September 24, 2010

103-89500

**RE: PROJECT NO. 0950137-032-AC
REQUEST FOR ADDITIONAL INFORMATION (RAI)
STANTON ENERGY CENTER, UNITS 1 AND 2
HEAT INPUT INCREASE AND PERMIT MODIFICATIONS**

Figure 1. SEC Unit 1 4-Hr Average Output > 450 MW

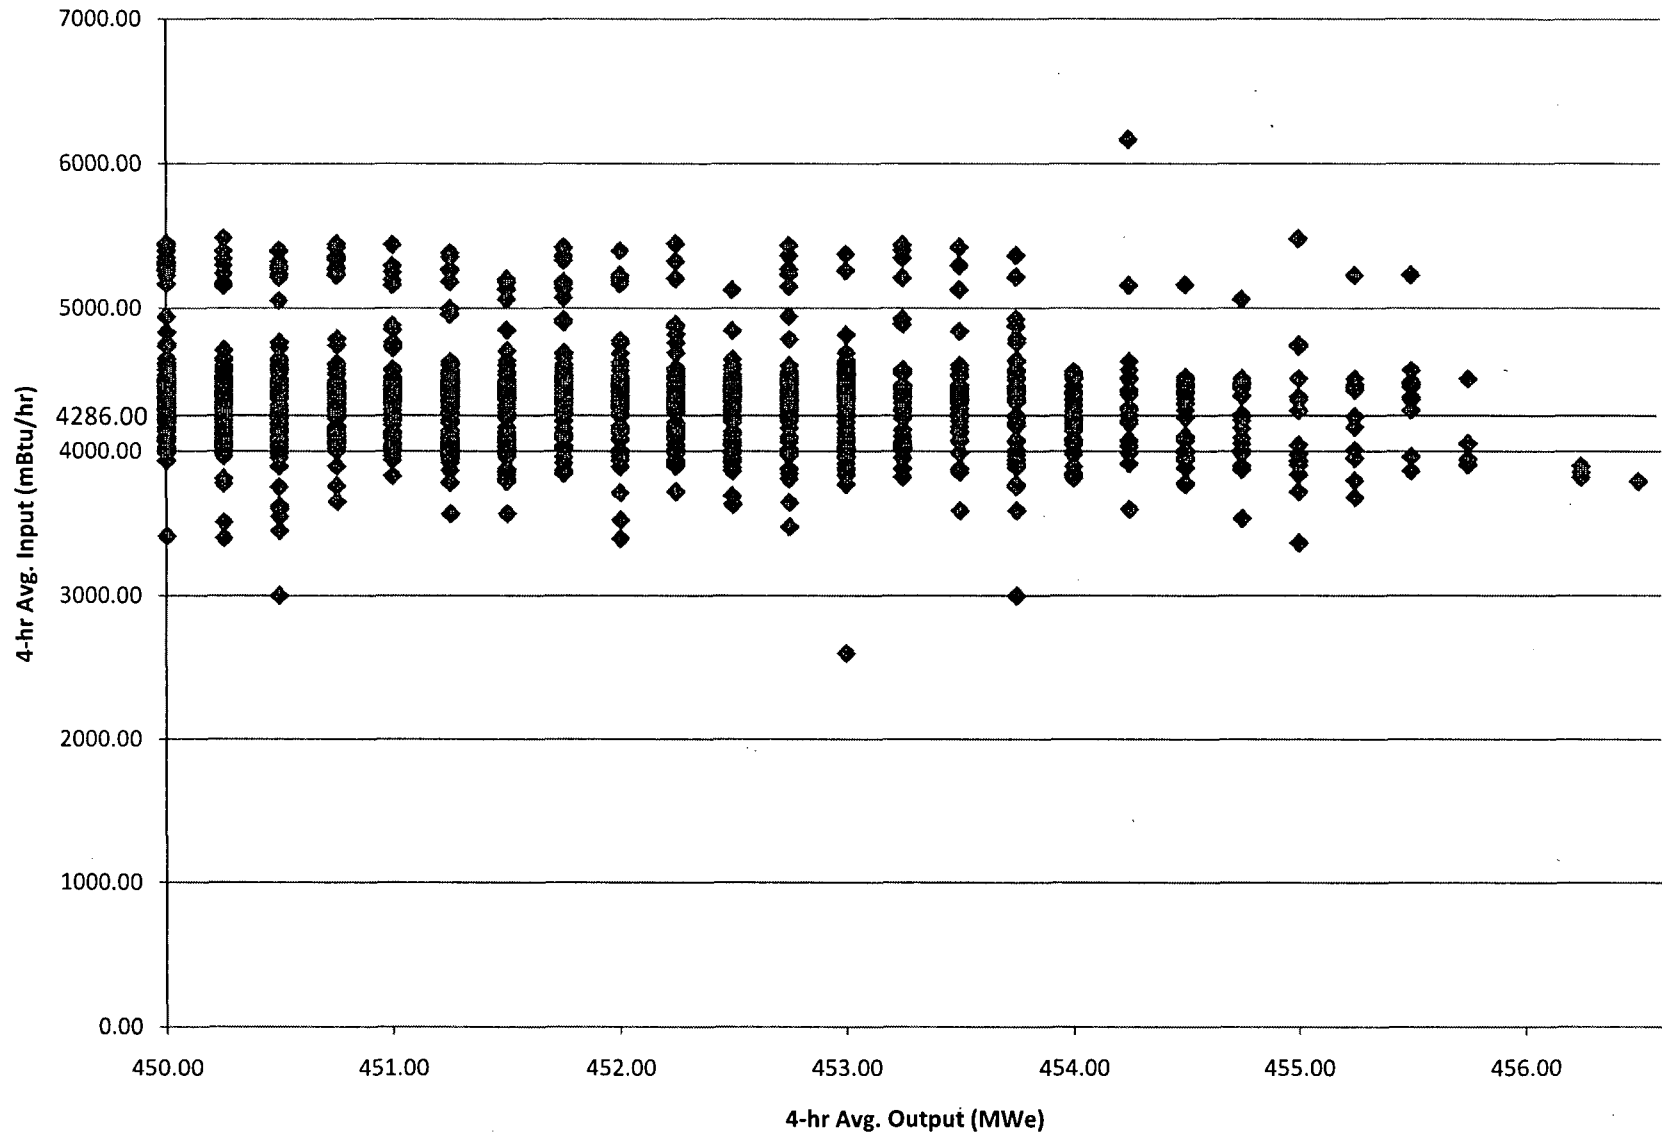
1. The original heat input limit for Unit 1 was 4,136 mmBtu/hr as part of the original site certification under PA81-14. This limit was increased to 4,286 mmBtu/hr under PSD-FL-084 as well as the limit for Unit 2 was set at 4,286 mmBtu/hr. Both units have been operating under these conditions since 1996. Based upon hourly acid rain data (calendar years 2005-2007), both units demonstrate the ability to operate at 468 MW and within the 4,286 mmBtu/hr limit. However, this information also shows the units operating above the heat input limit and the ability of the units to operate at the higher values. Provide an explanation for the numerous heat input rate excursions when the facility has demonstrated the ability to operate at maximum generating capacity and within the permitted maximum heat input rates. Are there operational changes which could alleviate some of the issues such as coal storage or drying?*

Response: The Department is correct that the Acid Rain heat input data show the ability of both units to operate at greater than 450 MW and within the 4,286 mmBtu/hr heat input limit, as well as the ability to operate above the heat input limit and generate approximately the same MW output. In fact, attached are several figures that graphically depict this relationship (Figures 1 and 2, representing Units 1 and 2, respectively).

However, in spite of the units' recognized ability to operate at heat input levels above 4,286 mmBtu/hr, the Department's above-referenced anomaly merits explanation. Specifically, the Department points out the perceived ability of both units to operate at 468 MW and within the 4,286 mmBtu/hr heat input level, as well as the ability to operate above that level and generate approximately the same MW output. Generally, the explanation for the variation in reported heat input, for what appears to be the same MW output, can be summarized into the following categories:

- Fuel quality (e.g., Btu content, hardness, mill fineness, etc.);
- Moisture (in or on the coal, plus heat of evaporation loss);
- Boiler air (total excess air, plus dry gas loss); and
- Power plant operational procedures that dictate a required MW output, although the heat input may be variable

Consequently, there are several key variables outside of OUC's control, such as increased moisture impacts due to the weather and the granular nature of the coal retaining more moisture, which have a negative impact on boiler efficiency. The variable nature of Stanton Energy Center's delivered coal includes not just its granular nature, but the carbon content, heating value, ash, sulfur, etc. Even traditional mines have much more variability these days.

Figure 5. SEC Unit 1 4-Hr Average Input > 4,286 mBtu/hr
1997 Year

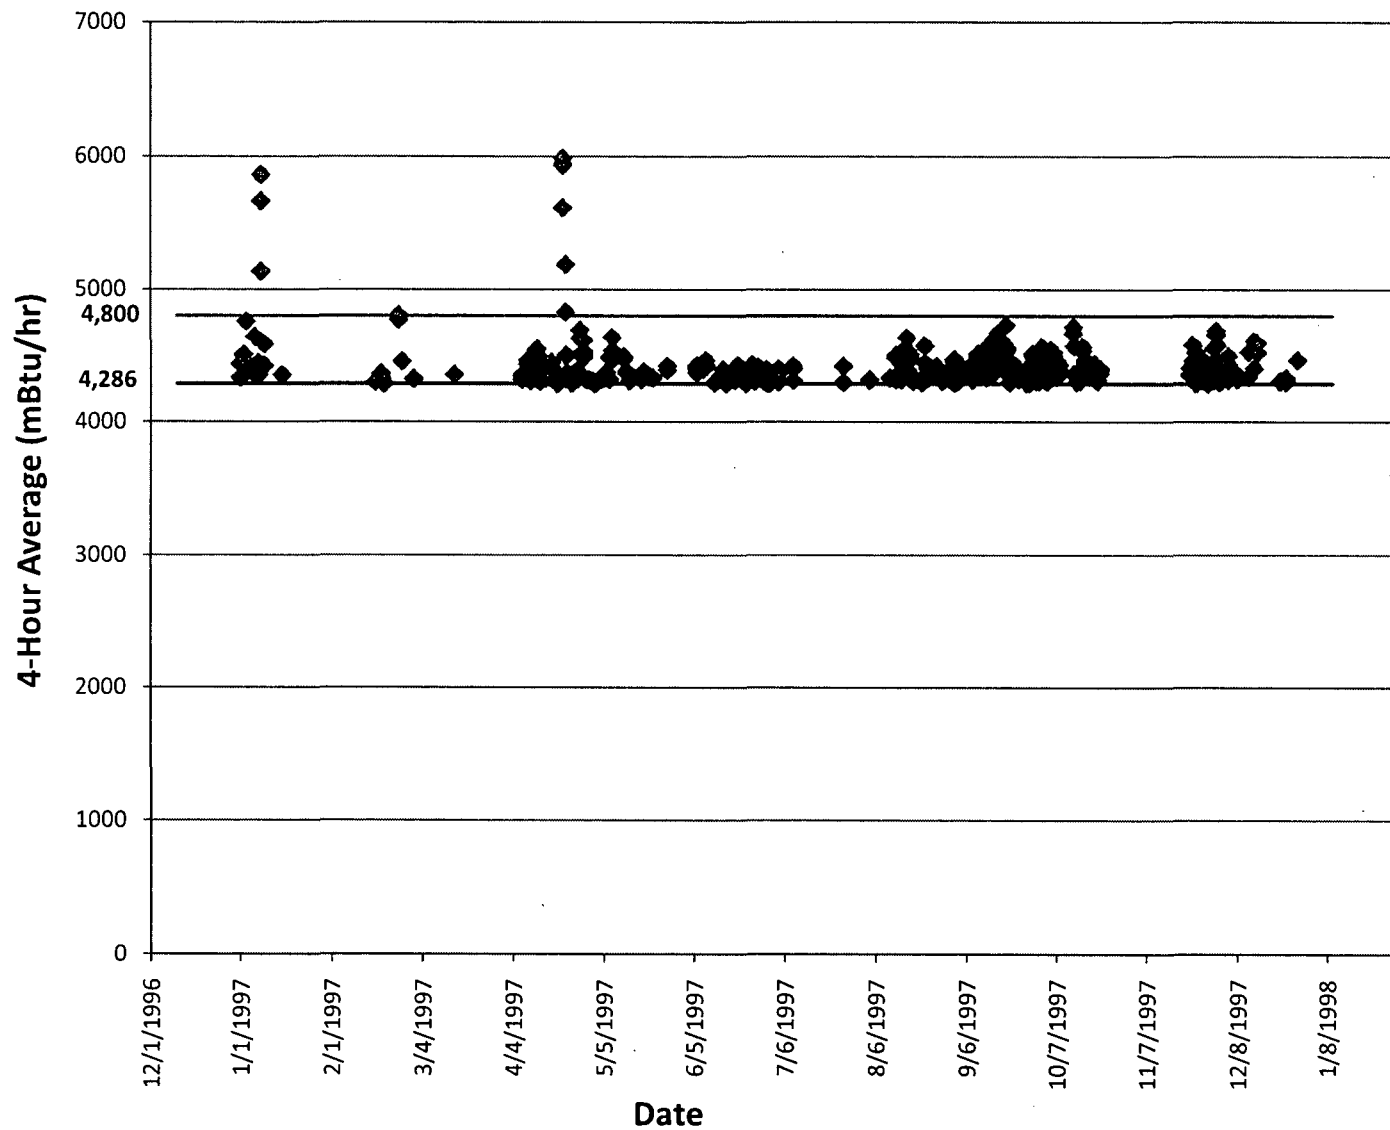
2. The units have shown the ability to operate at heat input values higher than the permitted values. Please provide any modifications to each unit which may have assisted in the units to perform at the higher heat input values. Please provide representative data documenting operation at elevated heat input rates from 1996 from 2004.

Regarding the documentation of elevated heat input rates over time, OUC initially reviewed Acid Rain heat input data from 2004 through 2009. At the Department's request, OUC has also gone back and assessed the data from 1997 (the first year in which CEMS data were available for these units). The data plots (see Figures 5 and 6) illustrate that these units have always had the capability to operate at these higher heat input levels. It is important to note that the heat input rate provisions included in the initial permits did not specify a method for monitoring and reporting heat input. Specifically, CEMS-measured heat input was generally acknowledged to be biased high at that time and there was no averaging period specified.
